# Access Compliance Report

## Public Rights-of-Way

Intersection ID: 47818	Main Street: ROYAL_FERN_LN	Cross Street: ROCKMOOR_RIDGE_RD	Location: SW
ADA ID: 4EAAD7D63BFD	Ramp Type: PerpDiag	Initial Pass/Fail: Fail	Overall Compliance: No
Severity Score: 37.5			
Codes/Mitigation Info/Possible Solution		Field Measurements/Component Compliance

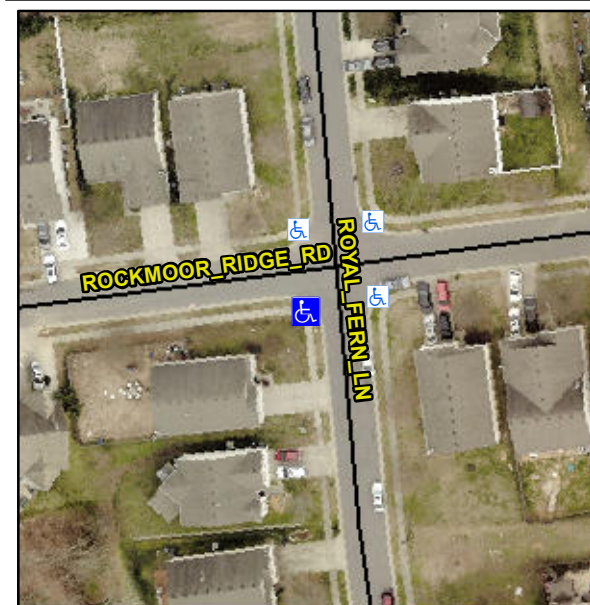
**Not Found, R304.2.2, R304.5.3**

Compliance	Description	Data	Compliance	Description	Data
N/A	Ramp Length (in)	30.5	No	Ramp Slope (%)	9.0
Yes	Ramp Width (in)	48.0	No	Ramp XSlope (%)	8.5
N/A	Flare Type LT	N/A	N/A	Flare Type RT	N/A
N/A	Flare Slope LT (%)	N/A	N/A	Flare Slope RT (%)	N/A
N/A	Flare Traversable LT?	N/A	N/A	Flare Traversable RT?	N/A
N/A	Landing Length (in)	N/A	N/A	DWS Provided?	N/A
N/A	Landing Width (in)	N/A	N/A	DWS Contrast?	N/A
N/A	Landing Slope (%)	N/A	N/A	DWS Length (in)	N/A
N/A	Landing X Slope (%)	N/A	N/A	DWS Full Width?	N/A
N/A	Landing Curb? (Y/N)	N/A	N/A	DWS Offset (in)	N/A
N/A	Shared Landing?	N/A			
N/A	Gutter Ponding?	N/A	N/A	Gutter Slope (%)	N/A
N/A	Gutter Lip Ht (in)	N/A	N/A	Gutter X Slope (%)	N/A
N/A	Painted X Walk1?	No	N/A	Painted X Walk2?	No
	X Walk 1 Direction	To E		X Walk 2 Direction	To N
N/A	X Walk 1 Width (in)	N/A	N/A	X Walk 2 Width (in)	N/A
	X Walk 1 Slope (%)	2.6		X Walk 2 Slope (%)	5.2
	X Walk 1 X Slope (%)	4.3		X Walk 2 X Slope (%)	2.5

**Remove & Replace Curb Ramp With Two New Directional Ramps or Equivalent.**
